# Design Calculation or Analysis Cover Sheet

3. Sv	vstem	<u> </u>				4	. Docun	nent Identifier		
	Handling Facility							C-WH00-001	00-000-00A	
5. Title							· · · · · · · · · · · · · · · · · · ·			
	Handling Facility Structural S	Steel Fra	ming

# Calculation/Analysis Change Notice

EL. 40 FT. (UNO) FLOOR FRAMING PLAN

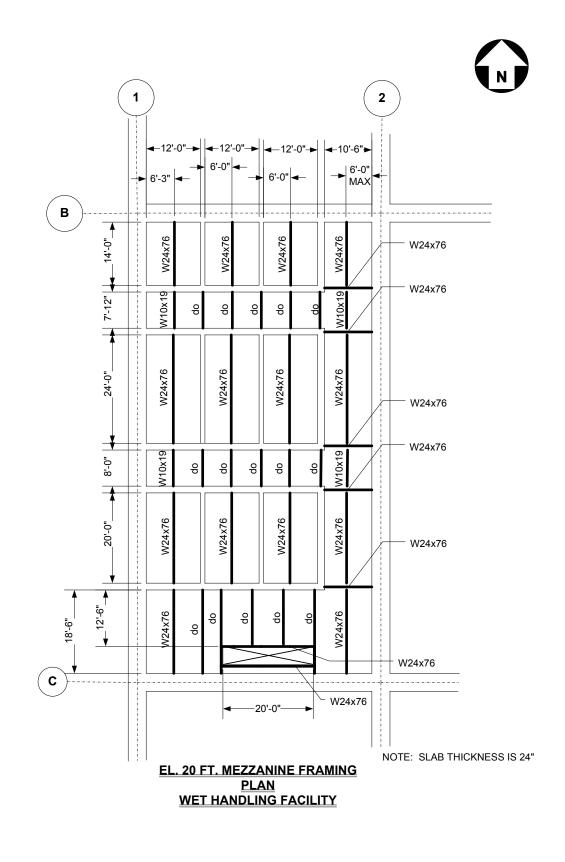
7. Reason for Change:											
To correct a typographical e											
correct section is W36X441											
Section 7.1. However, the "	$441^{\prime\prime}$ was inco	rrectly transcribed as	"411" onto the sketch. A W	36X411 section	i does not exist.						
Revising this calculation with	th the correct g	virder size addresses th	ne inconsistencies identified	in CR 10950.							
	Revising this calculation with the correct girder size addresses the inconsistencies identified in CR 10950.

10. Description of Change:	······	-,									
See Attachment A Dec	o A 2										
See Attachment A, Pag	e A-3.										
Change "W36X411" to	"W26V111	" in 2 places									
Change w 30,411 to	W 30A441	m 2 places.									
			·								
			·····
